**ASHLAND PLANNING COMMISSION
SPECIAL MEETING
NOVEMBER 25, 2014
AGENDA**

**ASHLAND PLANNING DEPARTMENT
STAFF REPORT – ADDENDUM 1**

PLANNING ACTION: 2014-01837

IN THE MATTER OF PLANNING ACTION #2014-01837, A REQUEST FOR)
SITE REVIEW APPROVAL TO PLACE A CANOPY OVER THE ASHLAND)
ROTARY CENTENNIAL ICE RINK, A RECREATIONAL FACILITY WITHIN)
LITHIA PARK, LOCATED AT 95 WINBURN WAY. THE APPLICATION)
ALSO INCLUDES REQUESTS FOR AN EXCEPTION TO THE SITE DESIGN) **FINDINGS,**
AND USE STANDARDS' HISTORIC DISTRICT DEVELOPMENT STANDARDS) **CONCLUSIONS**
IN SECTION IV-C AND FOR A VARIANCE TO ALLOW THE ICE RINK) **AND ORDERS**
CANOPY STRUCTURE TO BE PLACED WITHIN THE REQUIRED TEN-)
FOOT SIDE YARD SETBACK ALONG WINBURN WAY.)
)
)
OWNER/APPLICANT: City of Ashland/Ashland Parks & Recreation Department)
-----)

1 SITE PLAN
SCALE: 1"=20'

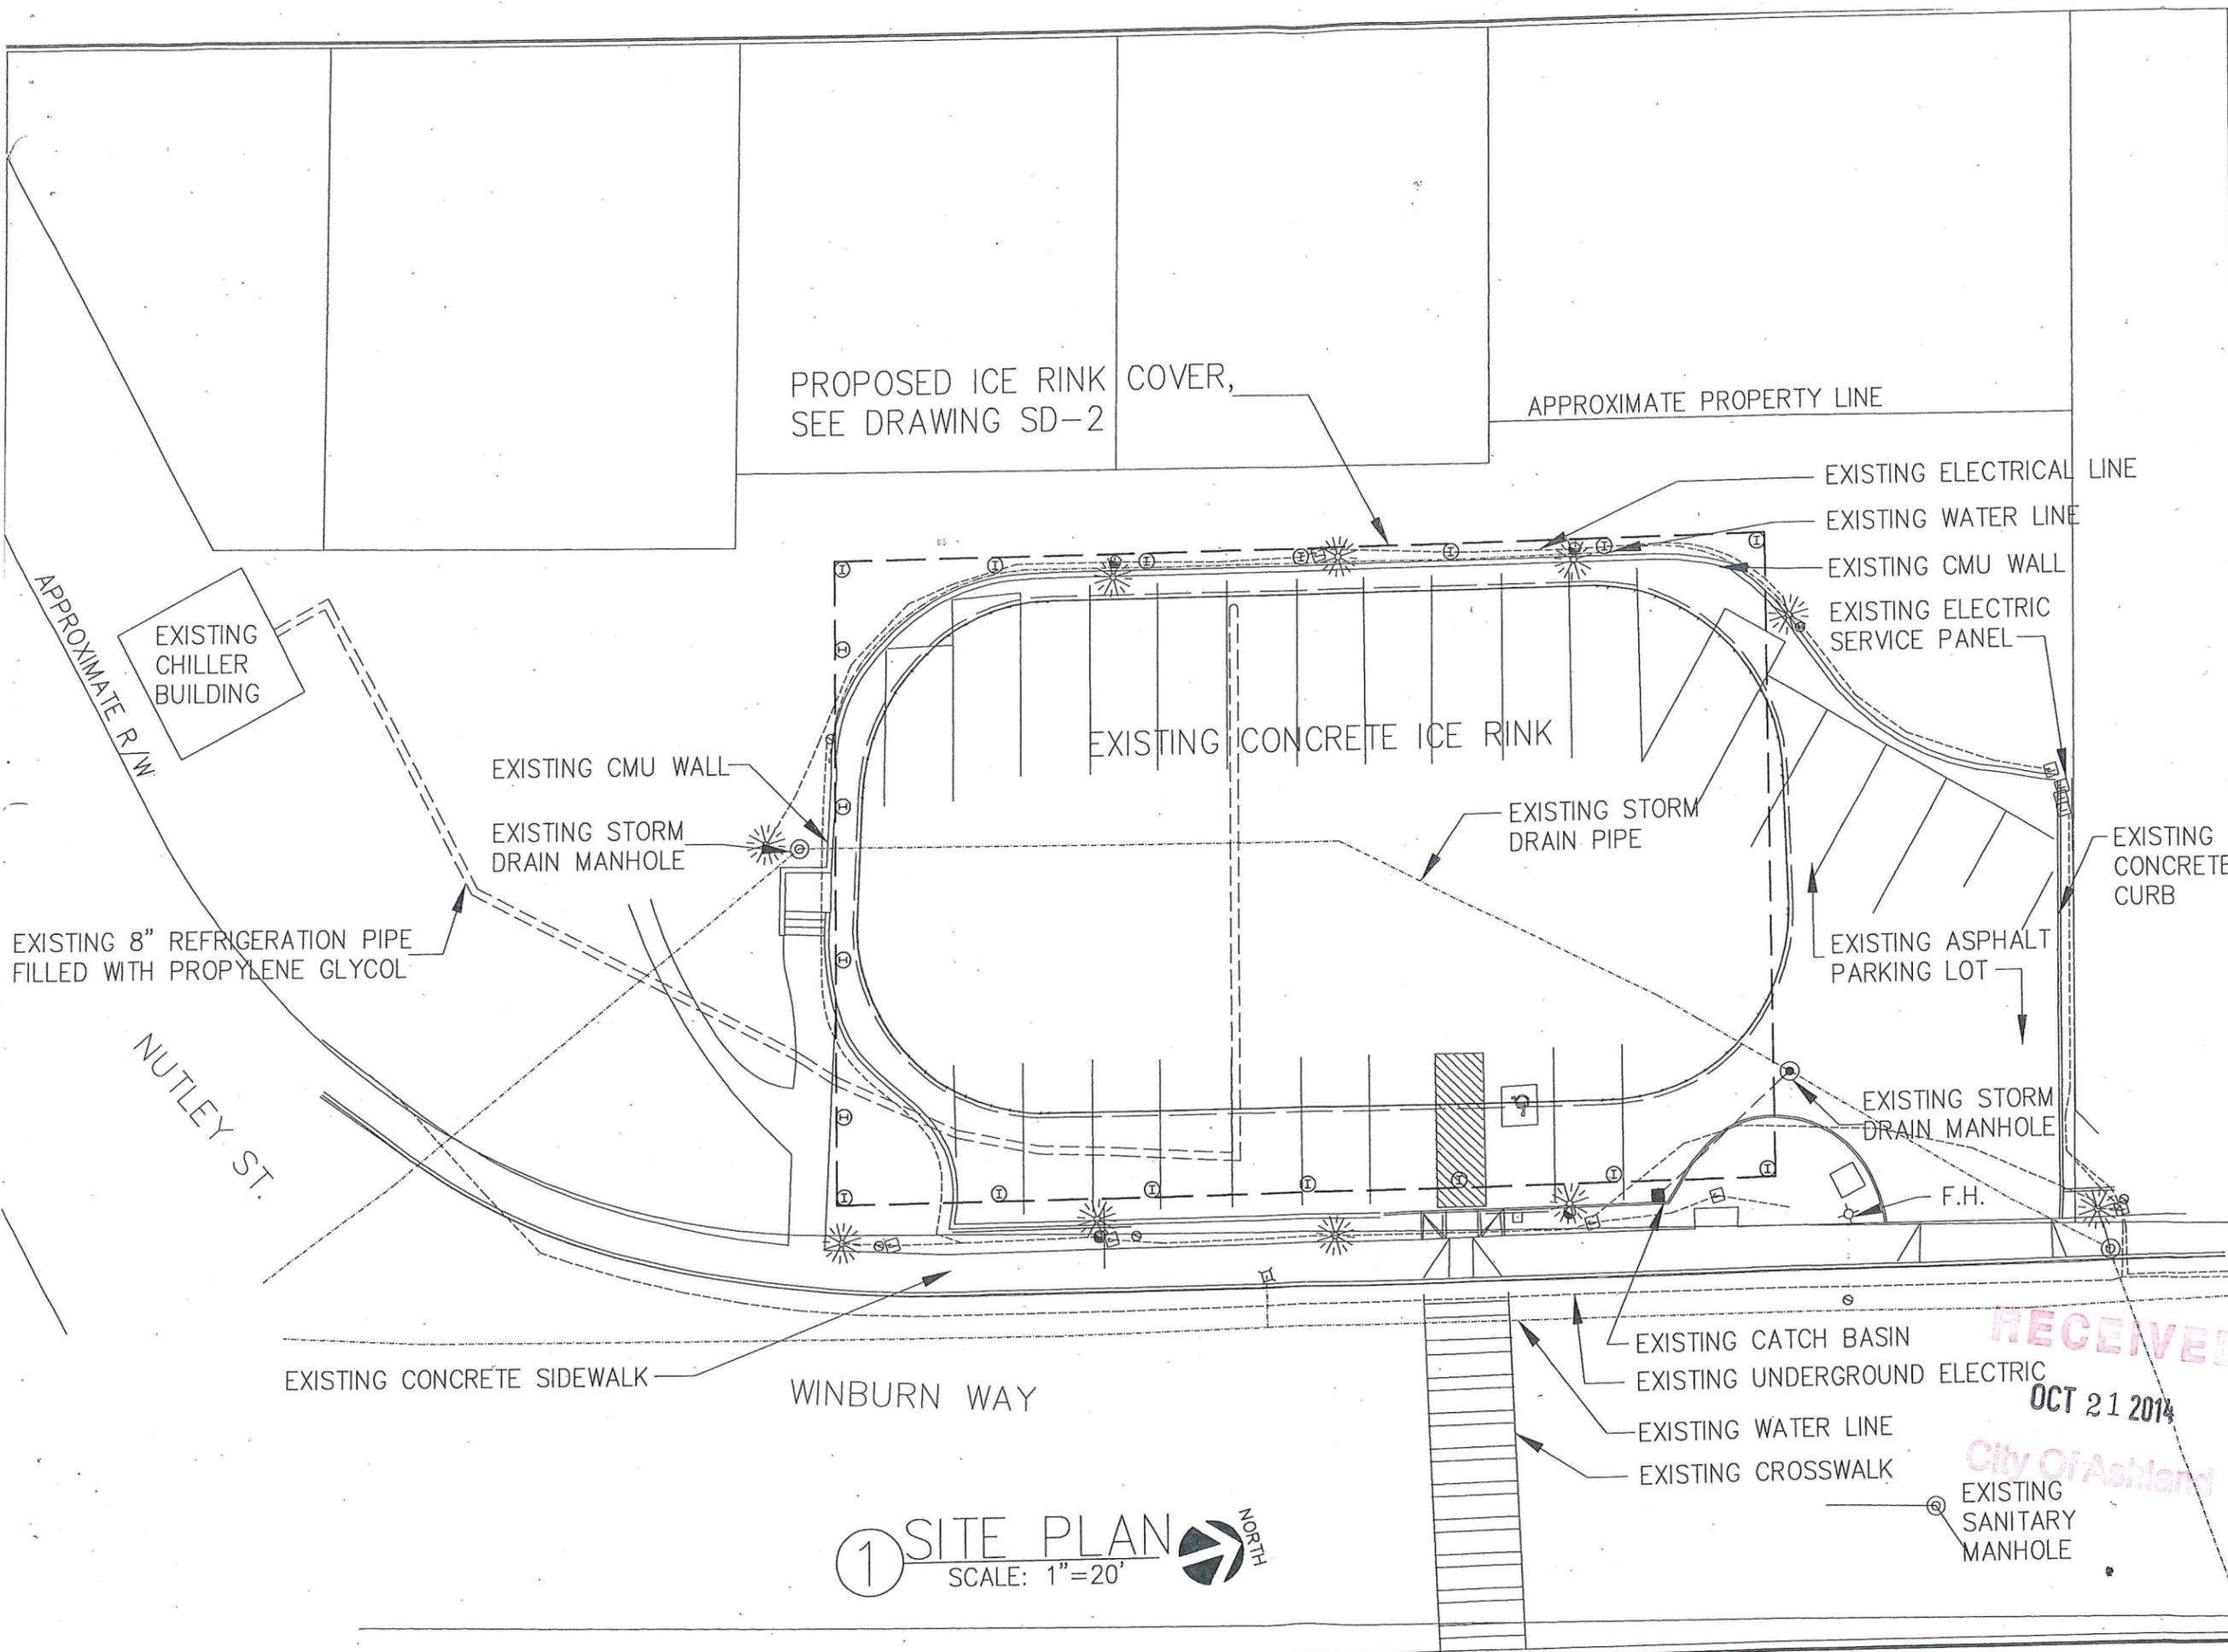
4. Changes to Part III – Project Drawings:
 - a. Drawing SD-2, Enlarged Site Plan. In the Enlarged Site Plan, change the approximate elevation of the SW column footing from +8'-0" to +6'-0".

SHEET TITLE
FOUNDATION PLAN

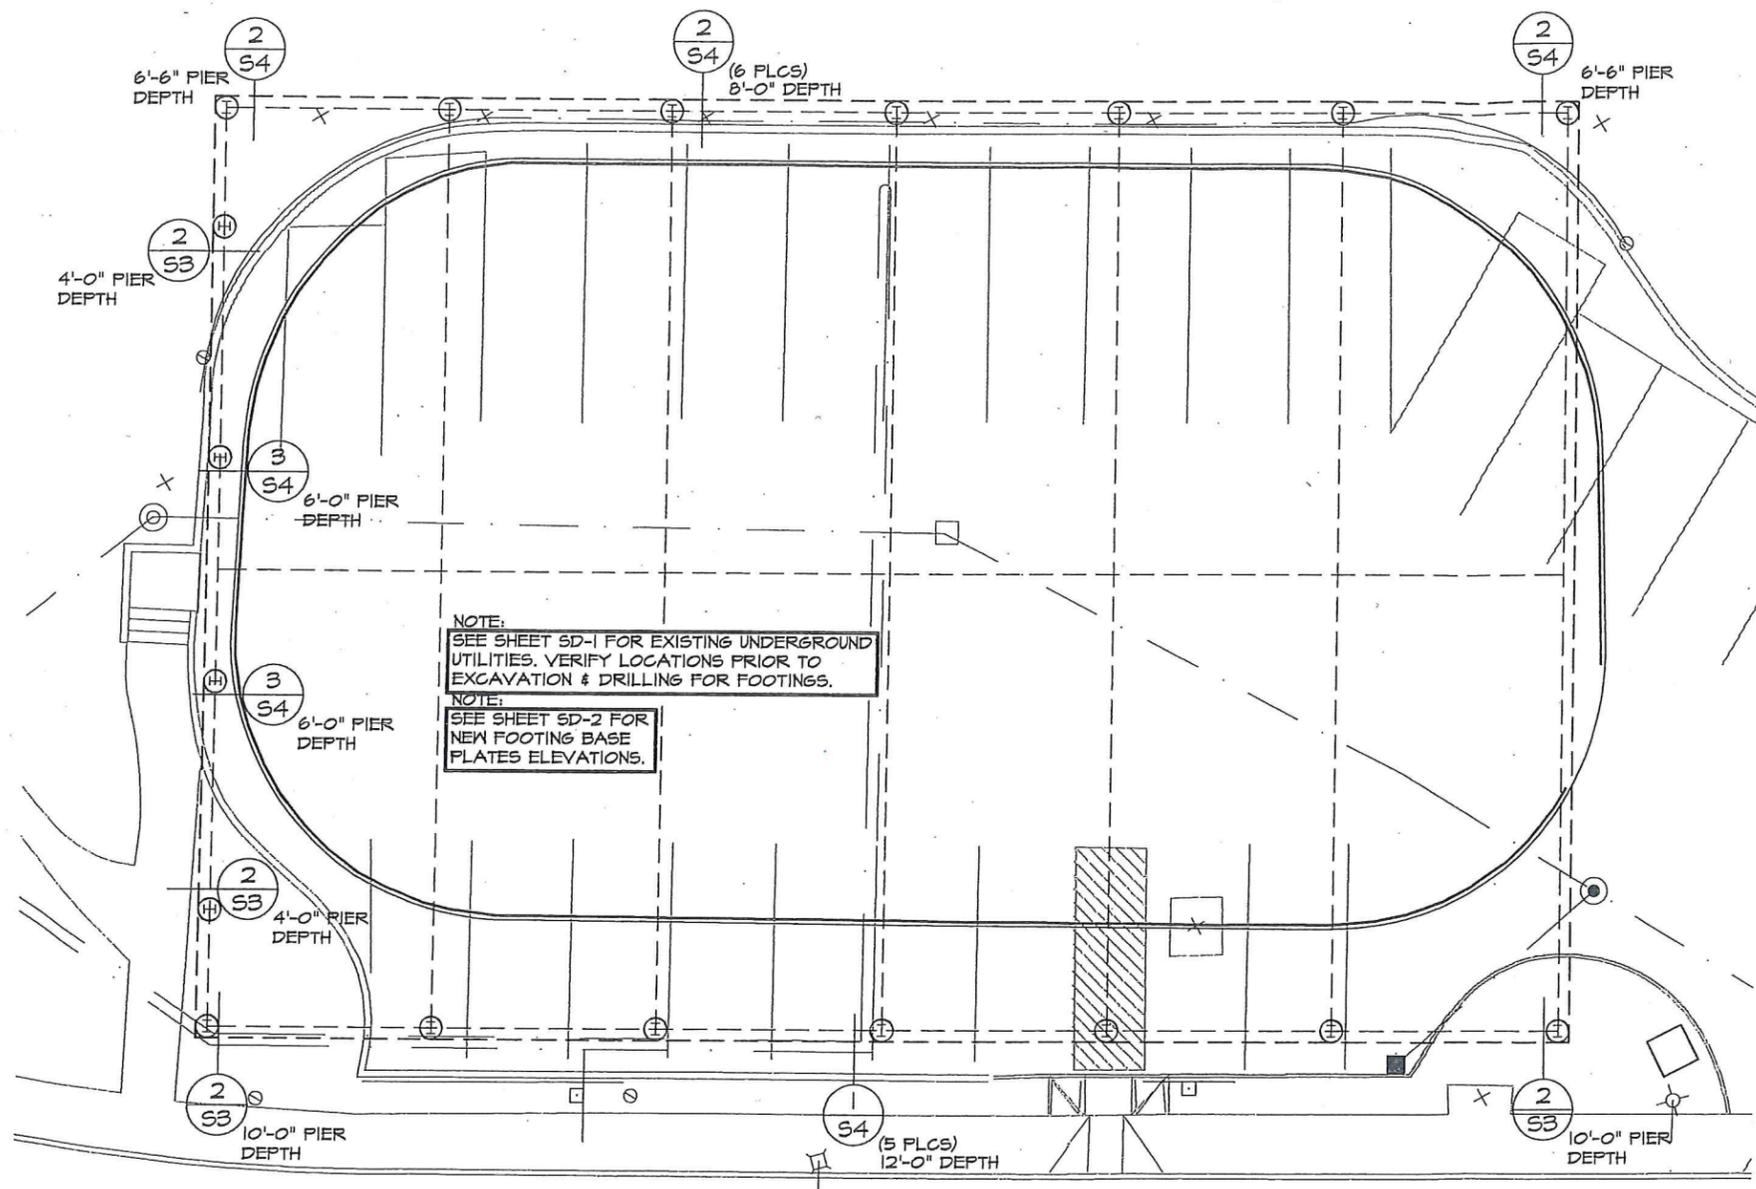
- b. Drawing S-3, Foundation Plan. Replace Drawing S-3 dated 08/7/13 with the attached Drawing S-3, dated 8/15/13. Pier depths have been changed in response to the attached Geotechnical Report.

SHEET TITLE STRUCTURAL DETAILS	
FILE NAME S-GEN.dwg	SHEET NO. S-4
DATE 08/07/2013	MAI PROJECT # 13-1114

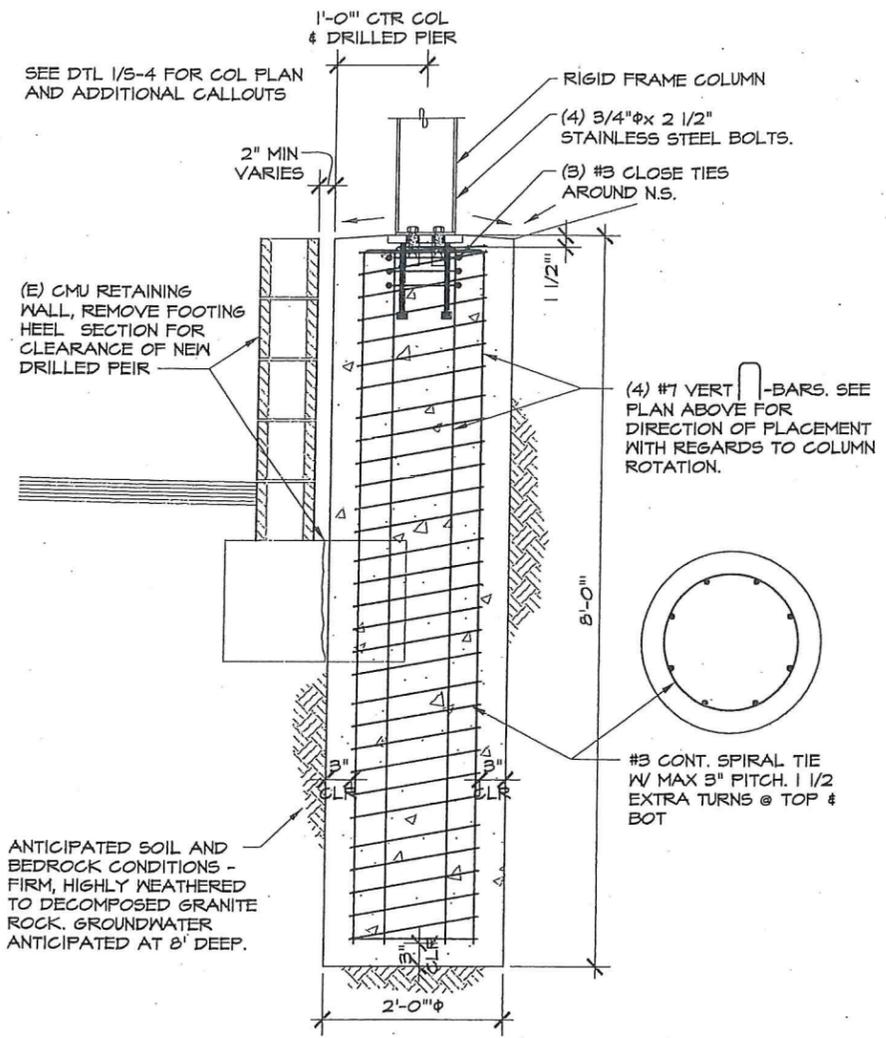
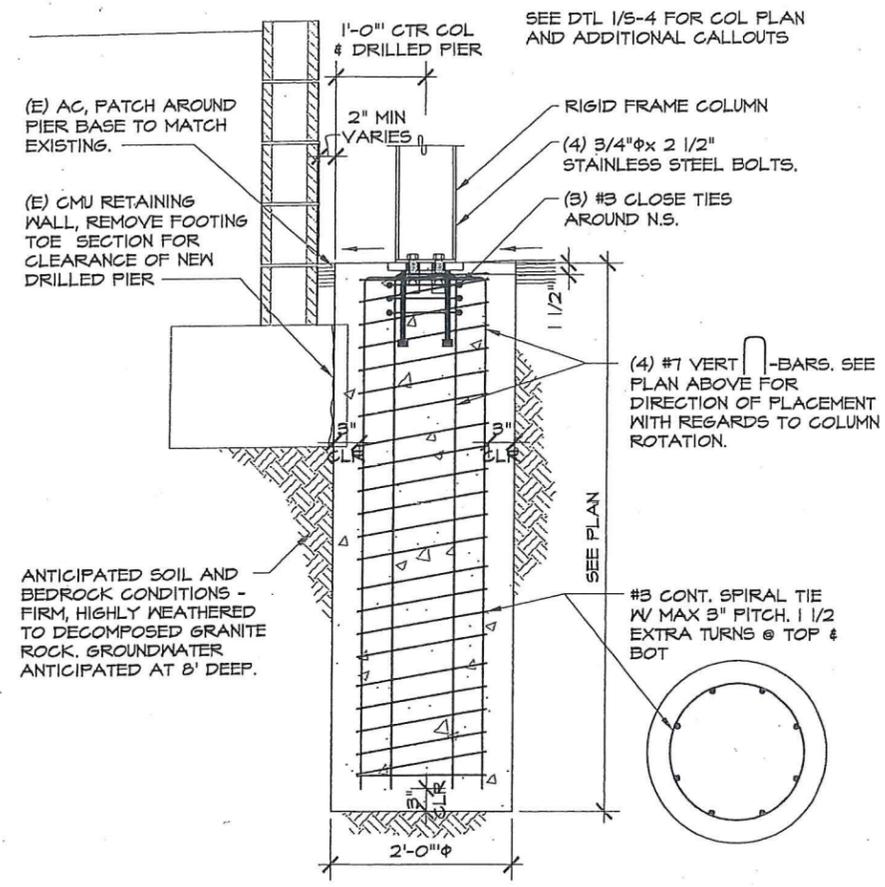
- c. Drawing S-4, Structural Details. Replace Drawing S-4 dated 08/7/13 with the attached Drawing S-4, dated 8/15/13. Pier depths at details have been replaced with a note to see the foundation plan in response to the attached Geotechnical Report.
